**Eugene School District 4J
ROOSEVELT MIDDLE SCHOOL**
680 East 24th Avenue
Eugene, OR 97405
CIP No. 410.566.001

ADDENDUM NO. 6

This Addendum forms a part of the Contract Documents and modifies the original Bidding Documents dated February 18, 2015 and subsequent addenda as noted below. Acknowledge receipt of this Addendum in the space provided on the Bid Form. Failure to do so may subject the Bidder to disqualification.

L-105.1

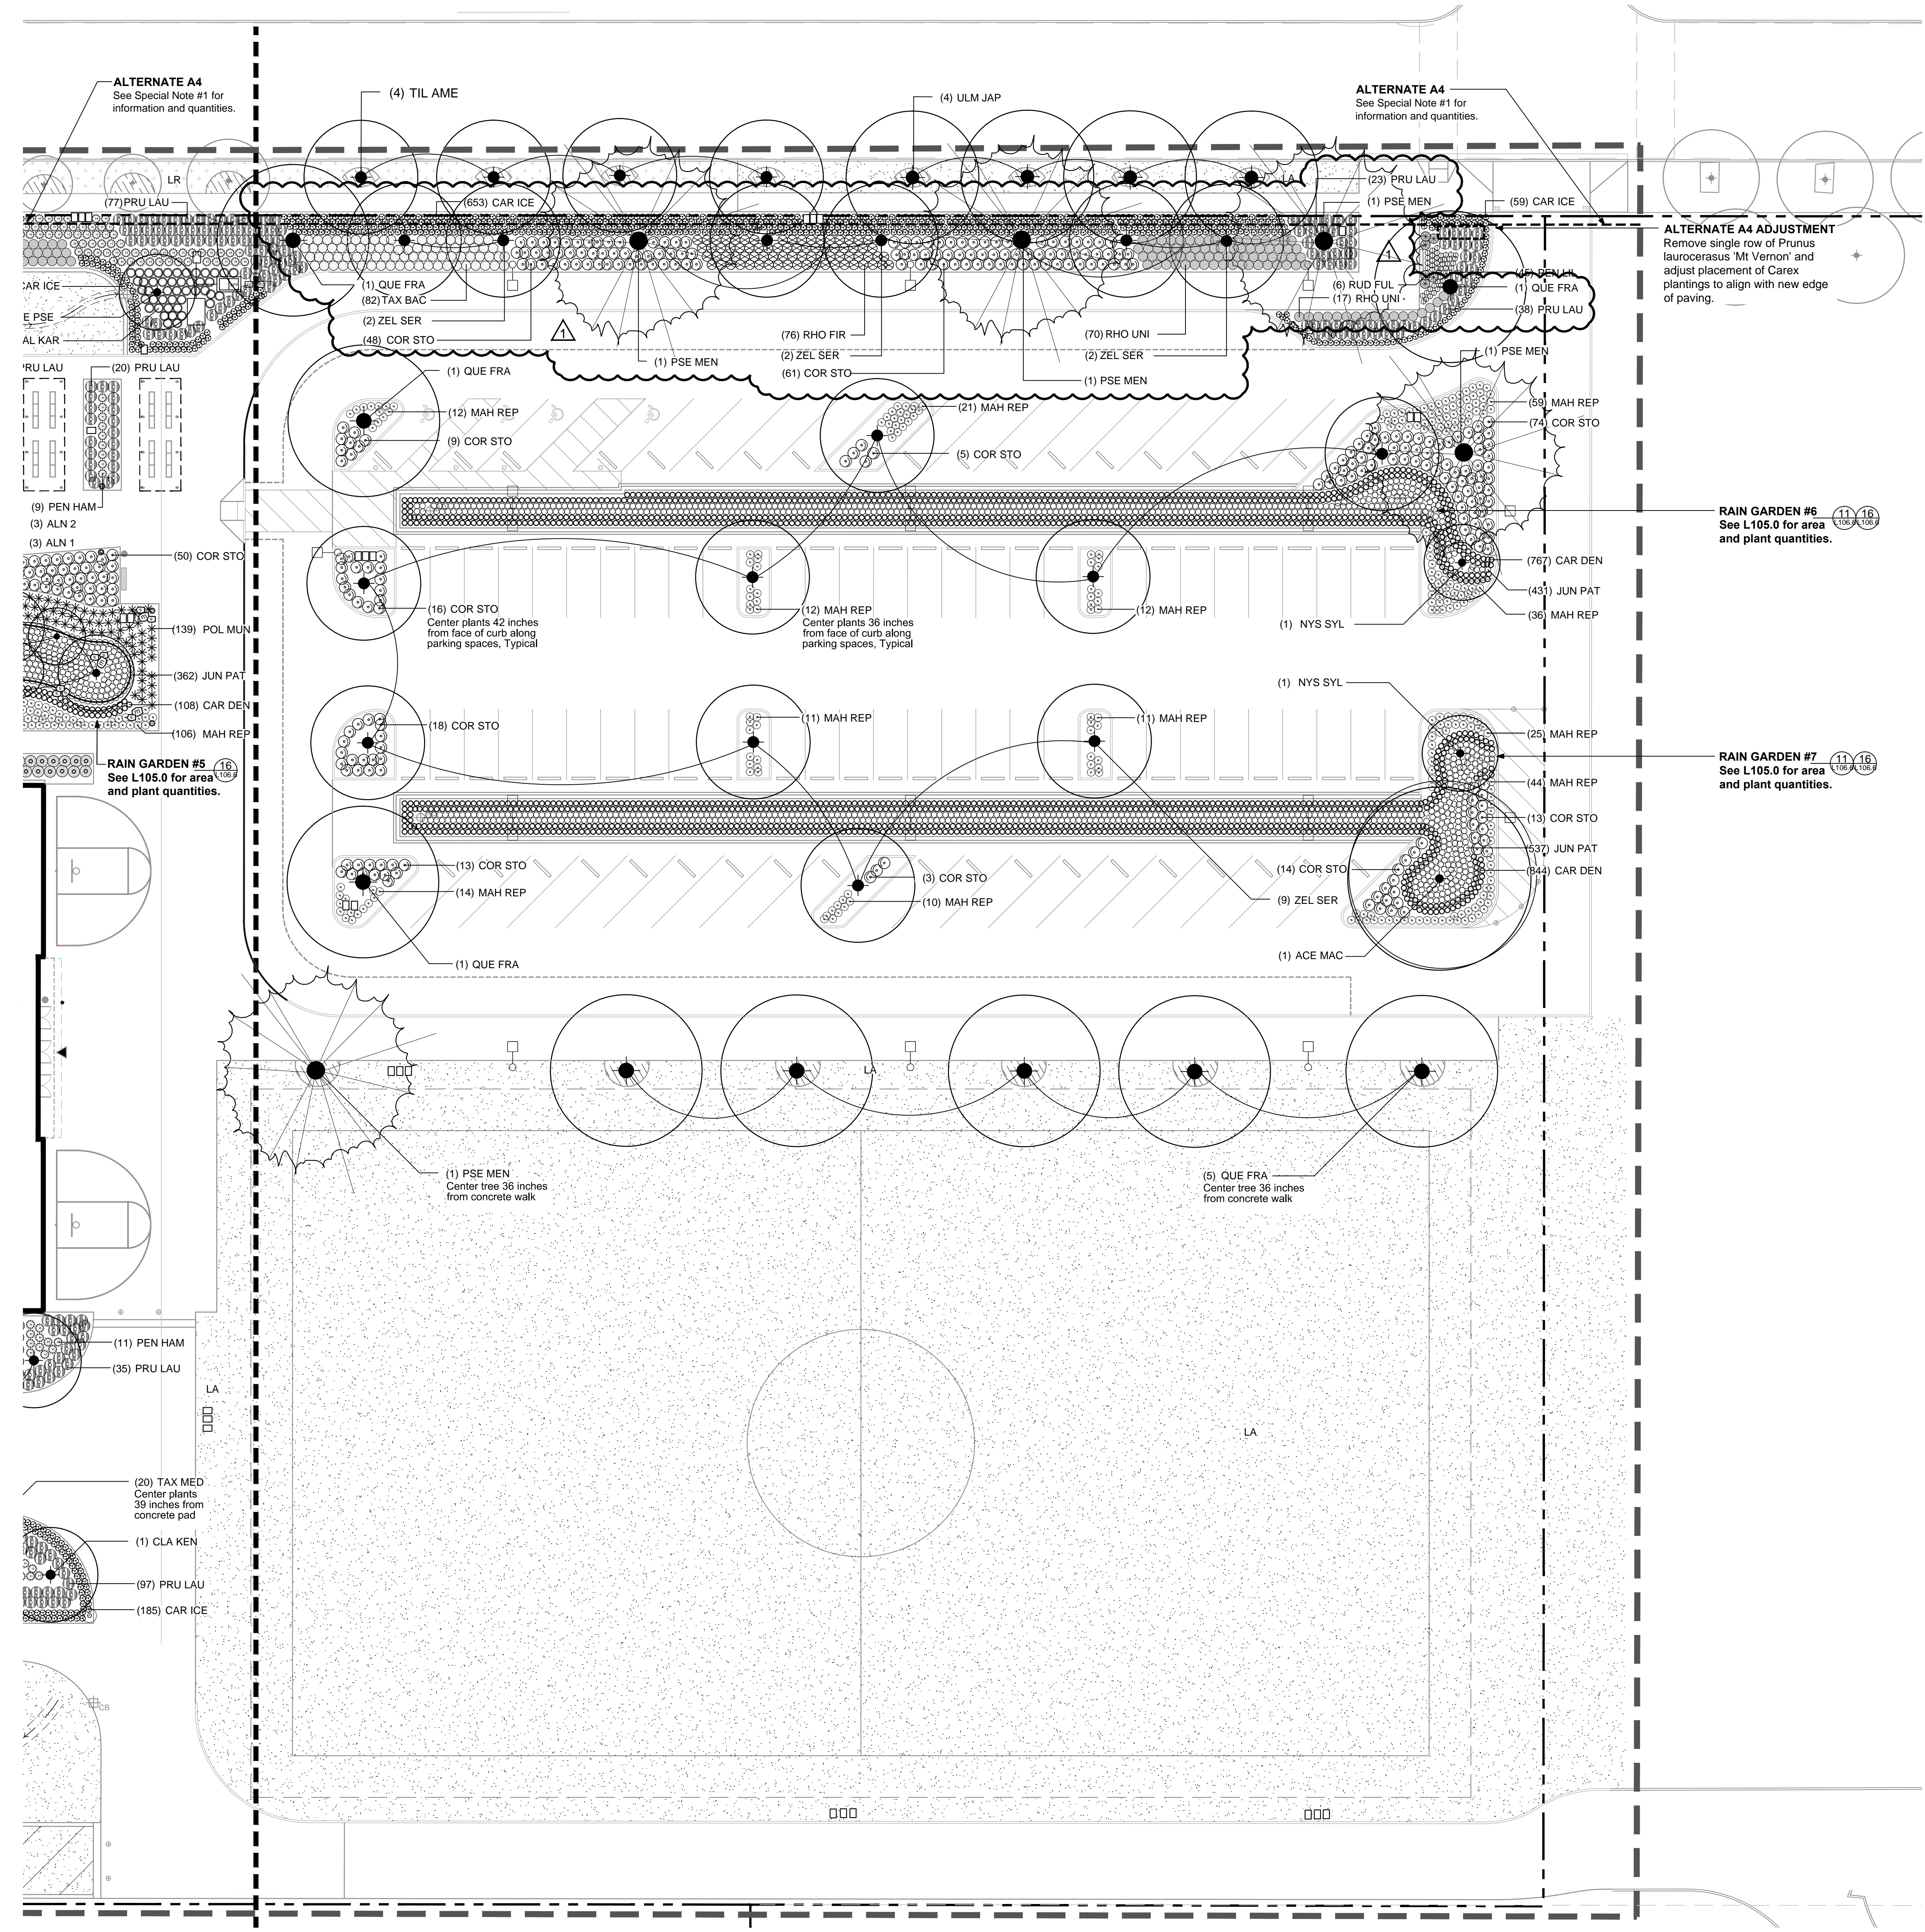
- A. Replace Sheet with revised Sheet L105.1: Adjust grassy swale area north of bus drop off area. Add landscape plantings between the entrance and exit of the bus drive per the City of Eugene Land Use Review Comments.

1 FIRST FLOOR PLAN - ZONE E
1/8" = 1'-0"

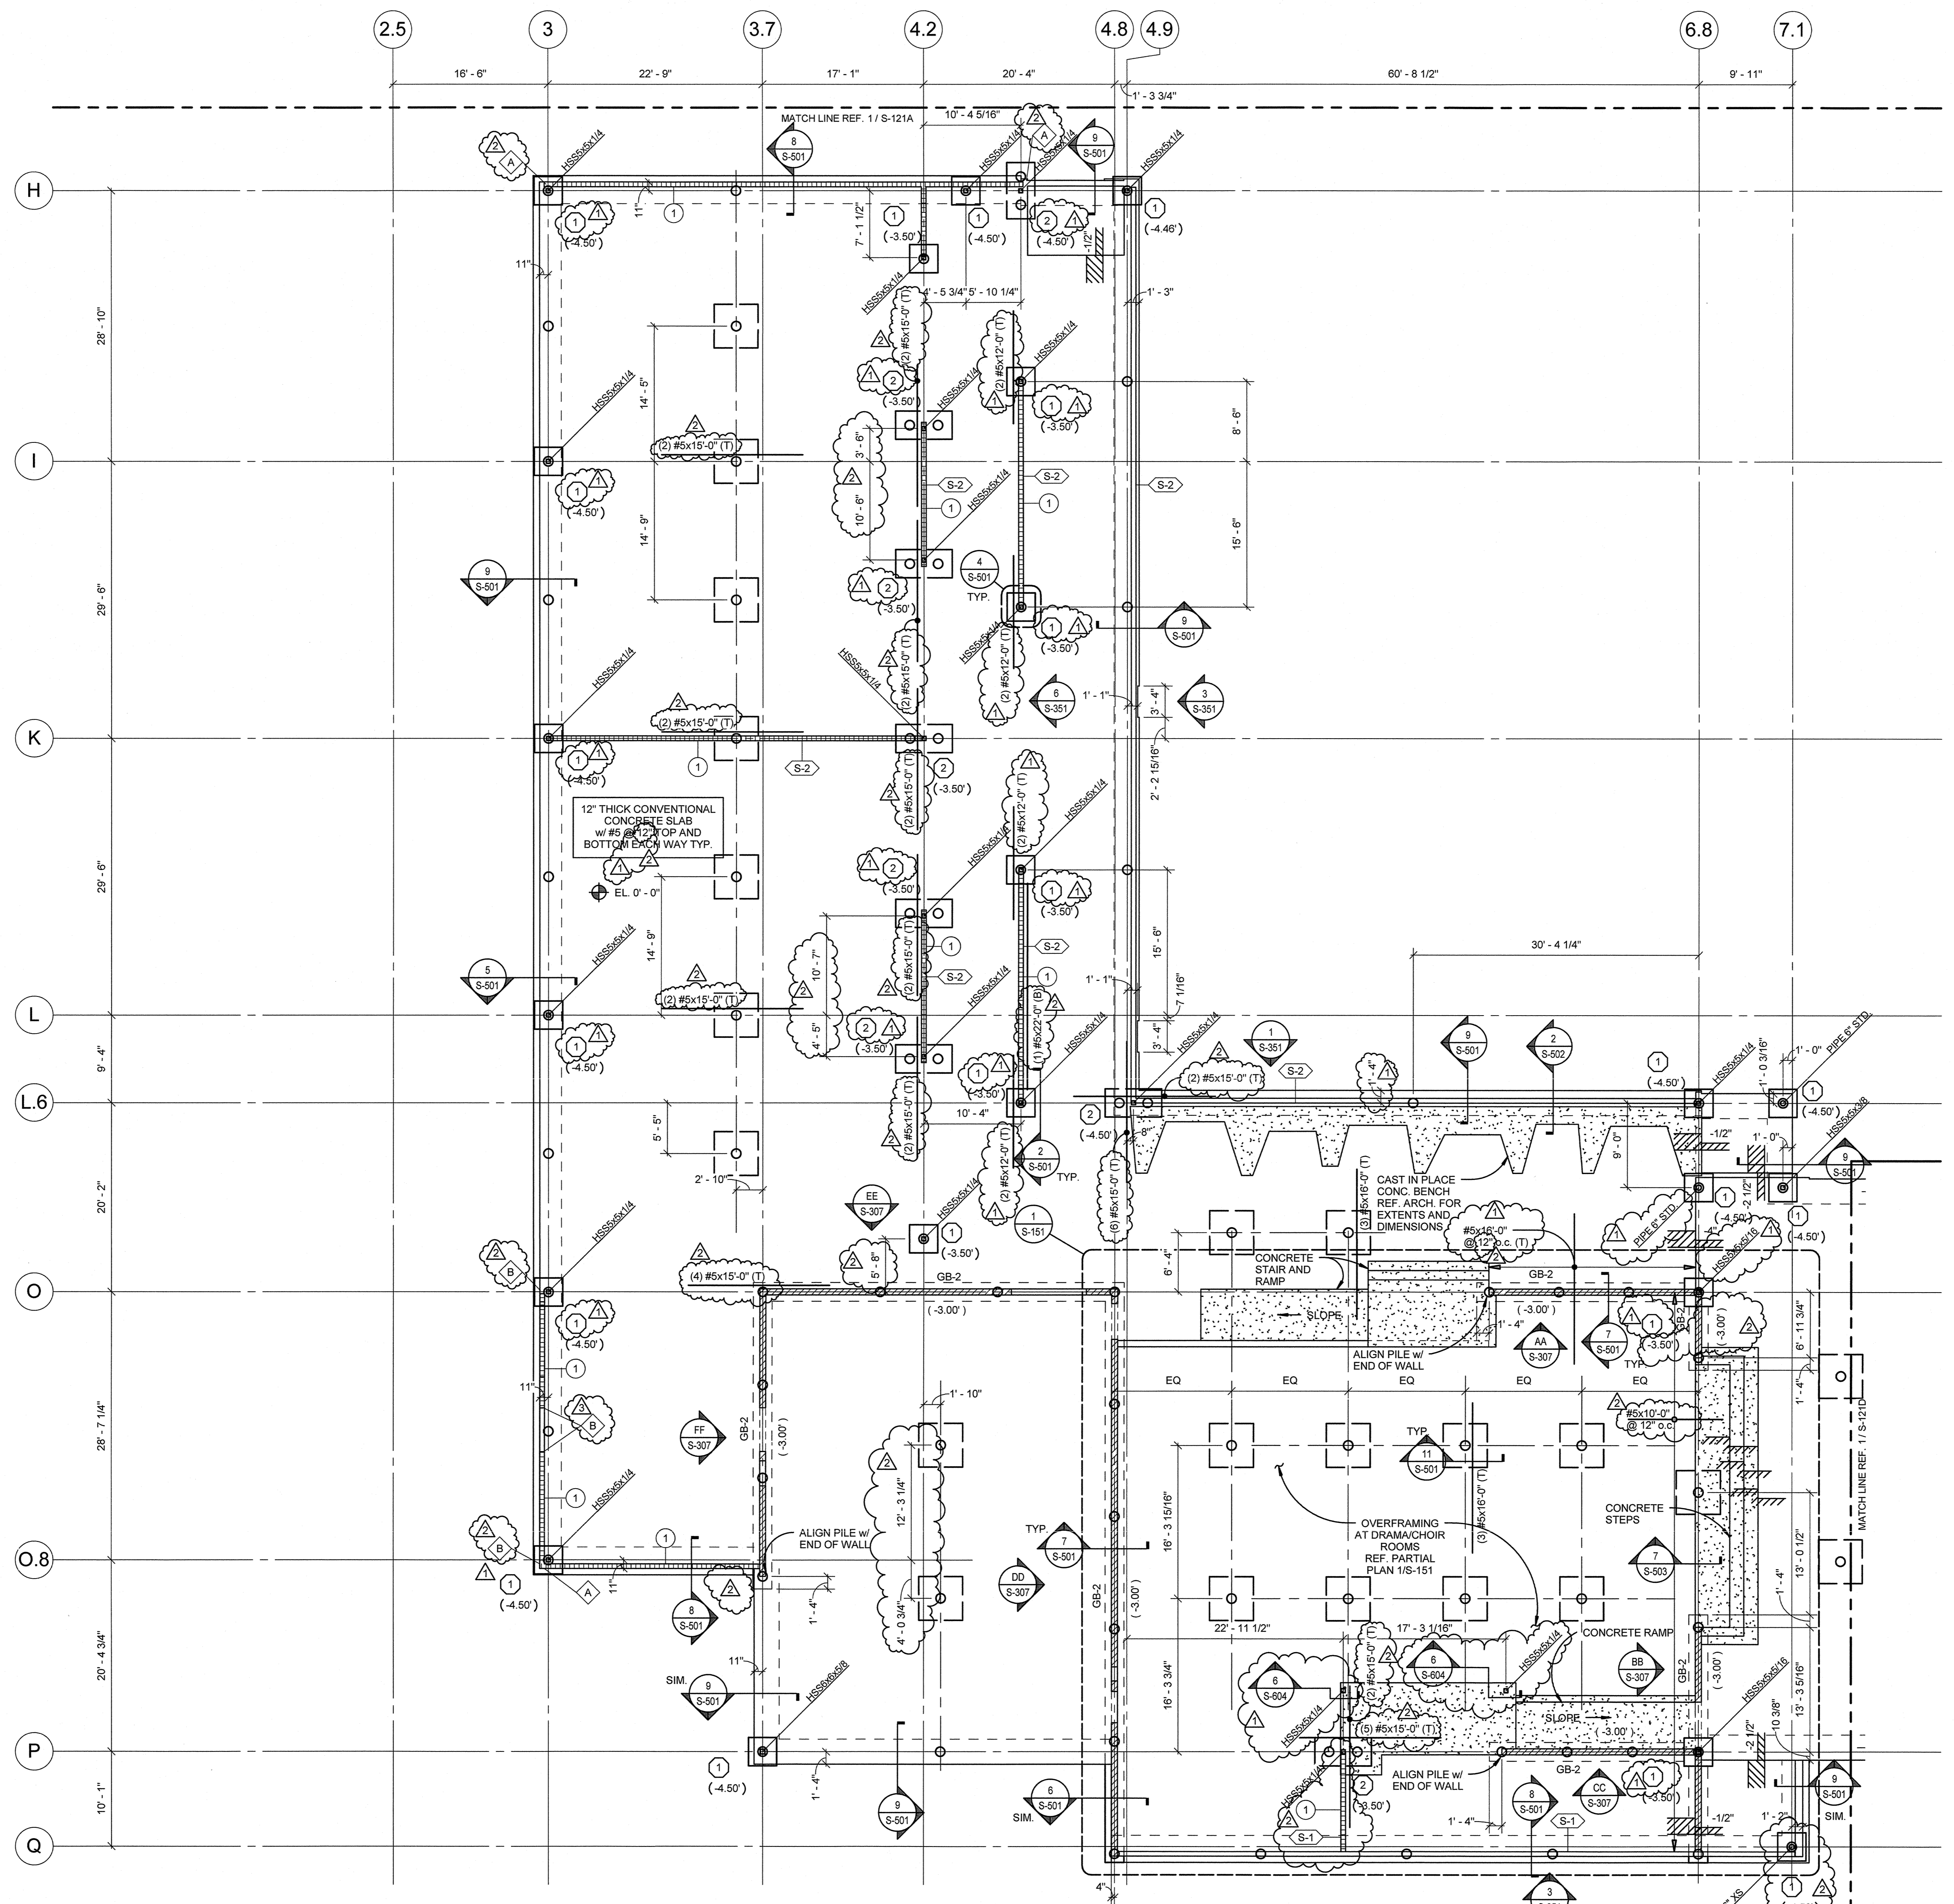
- A. Replace Sheet with revised Sheet S-121E: Change the Addendum 3 bubbles by adding the correct deltas.

HIGH ROOF PLAN - ZONE A

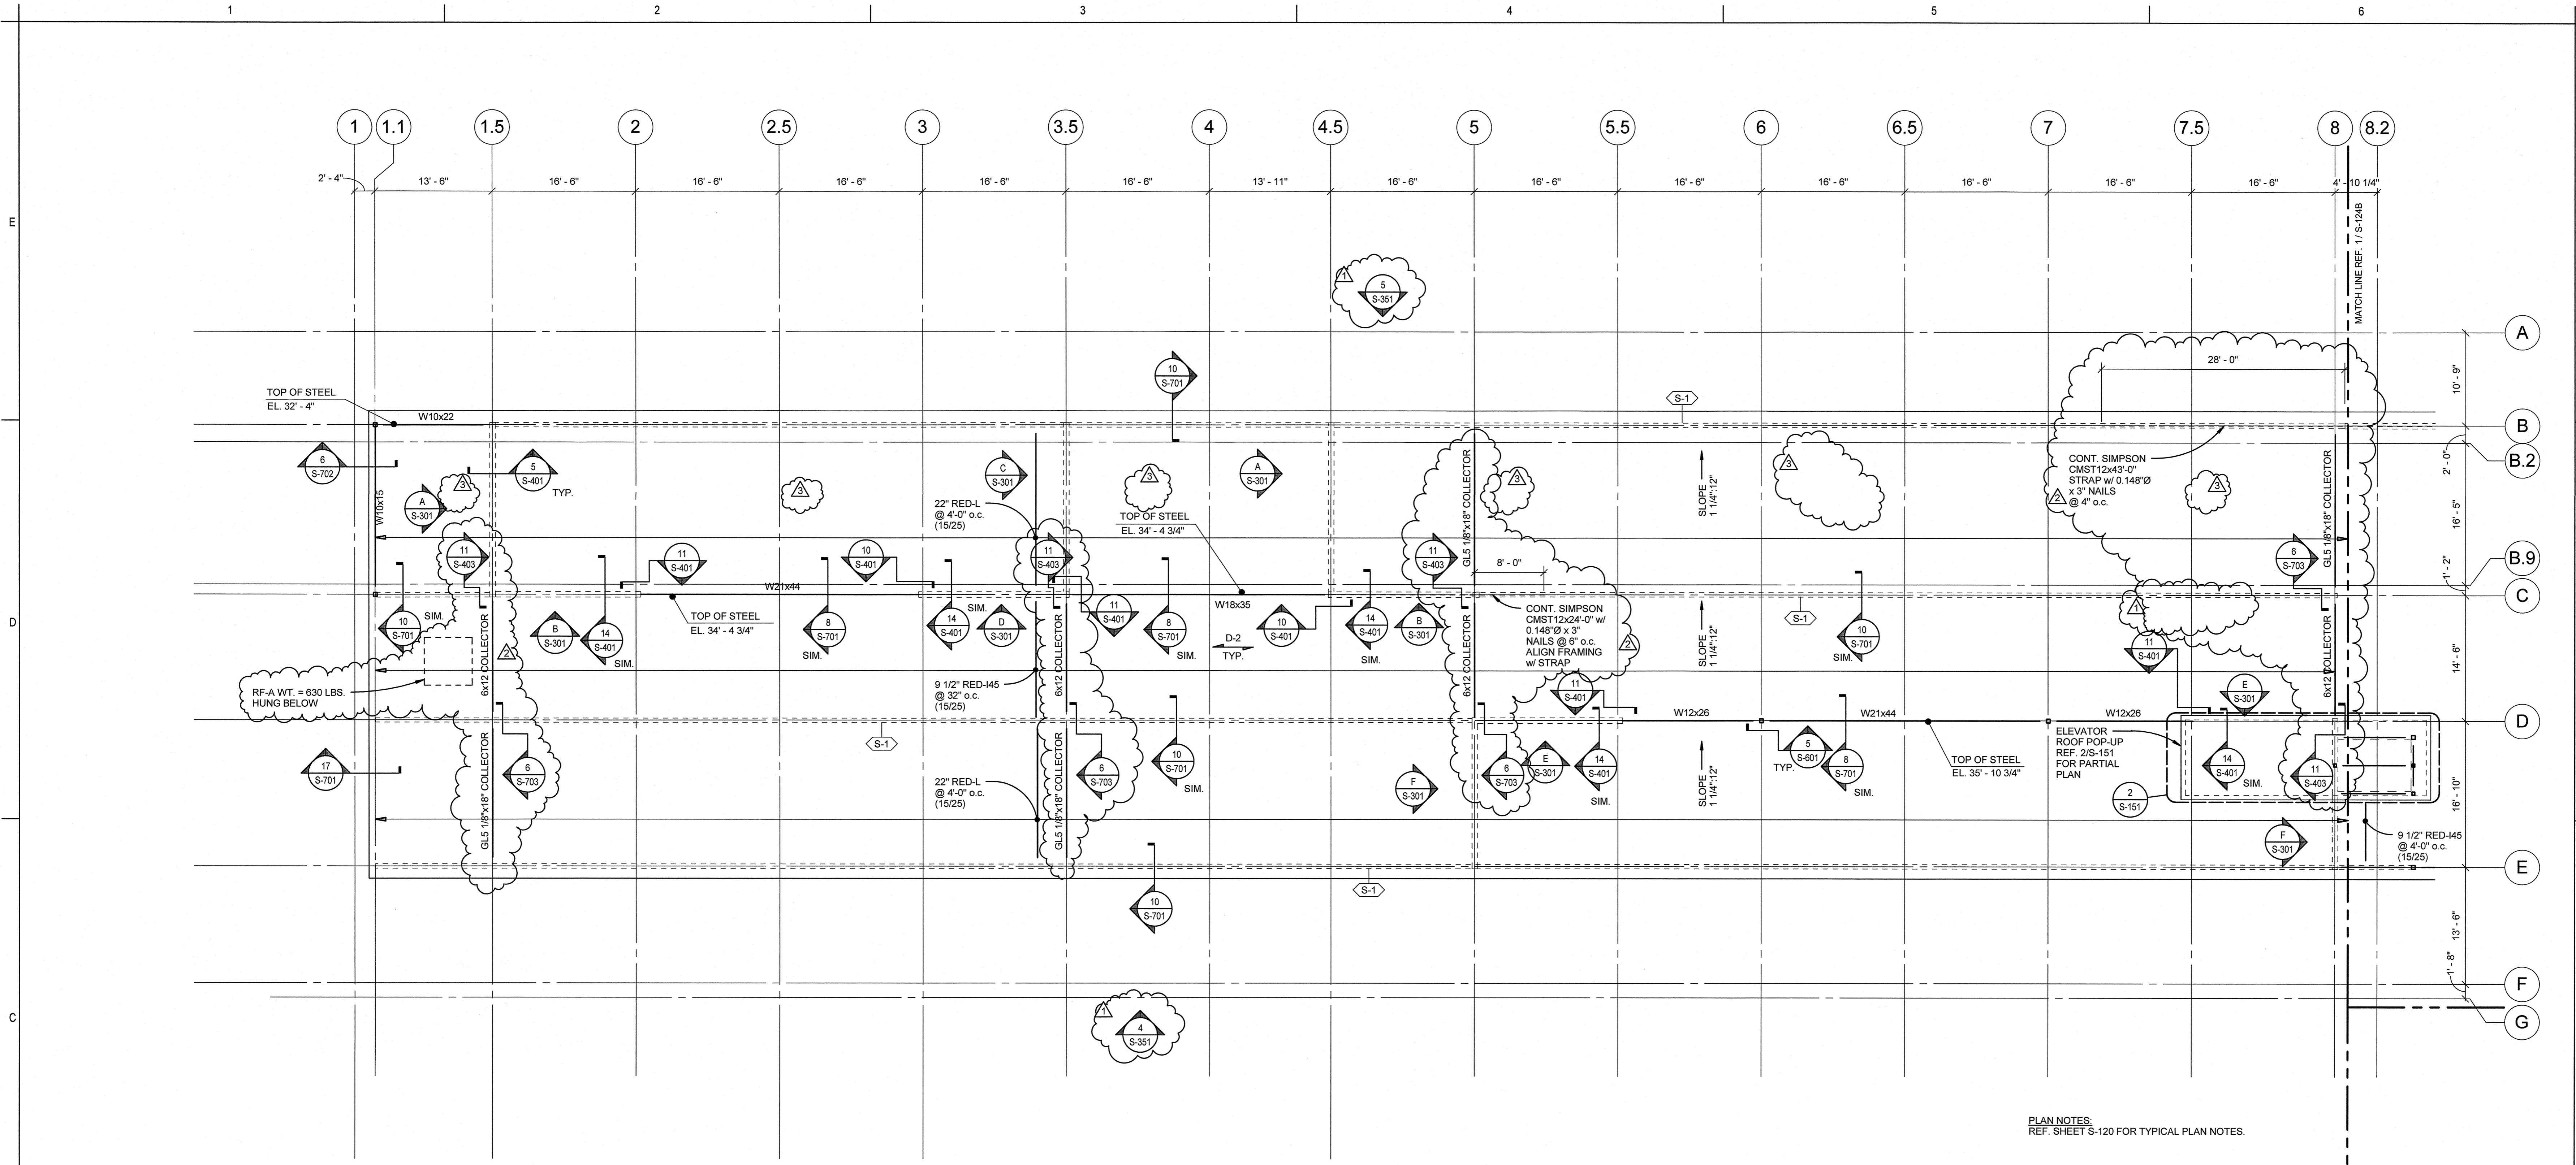
- A. Replace Sheet with revised Sheet S-124A: Delete the roof tie offs.
